ATTACHMENT

LIST OF OPEN ITEMS/NEW ISSUES, REVIEW BRANCH AND REVIEWER

Shearon Harris Nuclear Power Plant
DSER Open Item No. 372, Part 10 (ASB Review Question 10.4.9(10))

Shearon Harris Nuclear Power Plant
Draft SER Open Item 63
Supplemental Information

Figure 1 Block Diagram of DHMS

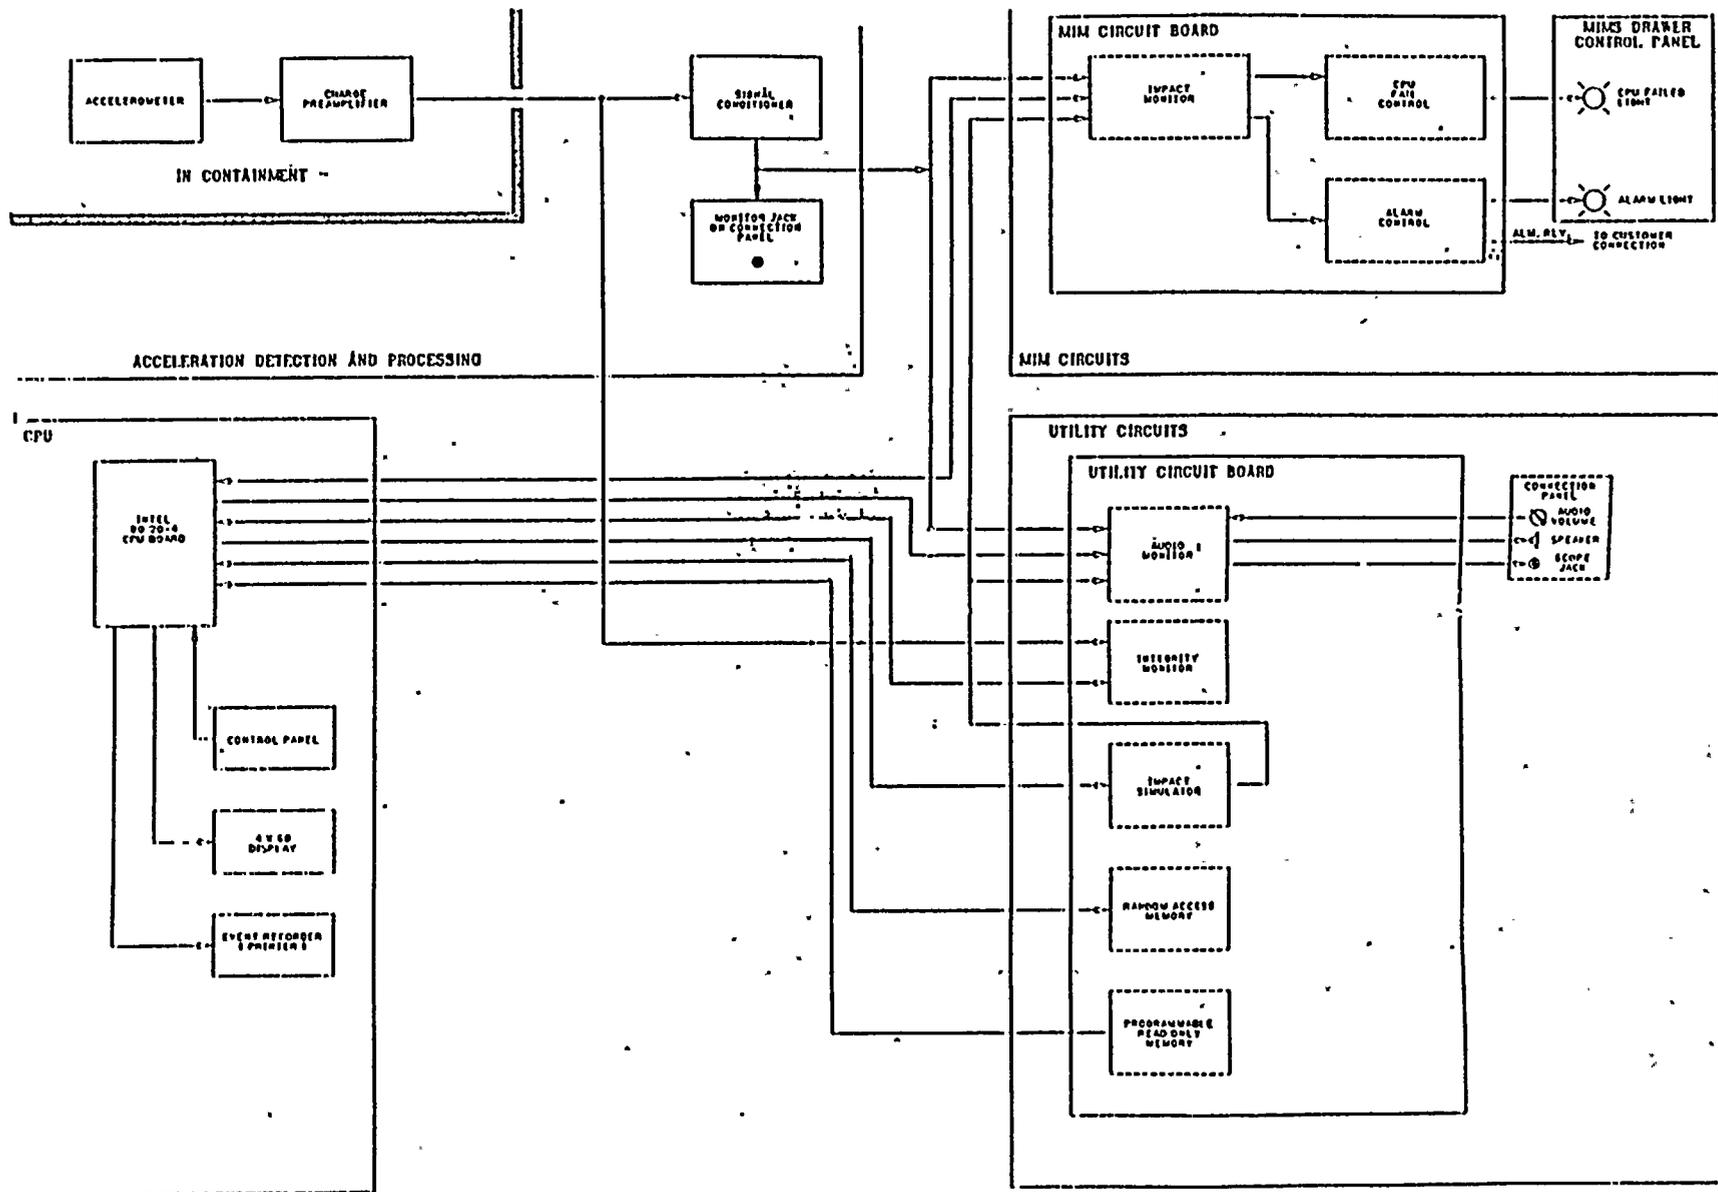
Evaluate the Loose Parts Monitoring System (LPMS) to be installed at SHNPP for conformance with Regulatory Guide 1.133 and provide a commitment to supply a final design report on the LPMS.

Figure 1 shows the major functional subsystems of the MIMS.

Pressure waves in the reactor coolant are detected as accelerations of the vessel external wall by strategically placed accelerometers. A charge preamplifier associated with each accelerometer provides a low-impedance representation of the detected acceleration.
